## TECHNICAL INFORMATION

-ZIB-132

## Re: Expanded Functions for the IC-703

Model: IC-703 (All versions)

### MAIN BOARD

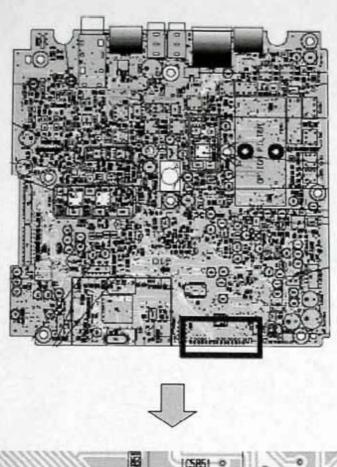
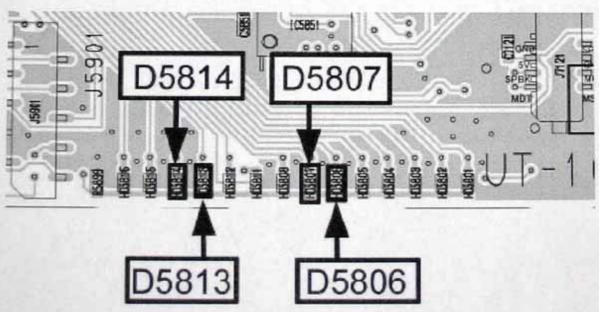
- (1) Frequency Coverage (Full TX expansion): 0.100000 60.000000 MHz
  Remove D5806 and D5807 on the MAIN board as shown in the attached diagram.
- (2) Frequency Coverage (Normal TX expansion): 1.600000 54.000000 MHz Remove D5806 on the MAIN board as shown in the attached diagram.

Remove D5813 on the MAIN board as shown in the attached diagram.

- (1) Install a diode (1790001250 MA2S111) to the position of D5814 on the MAIN board.
- (2) Push and hold [MODE] and [LOCK] keys and turn the power ON.
- (3) Select filter bandwidth by [FIL] key.
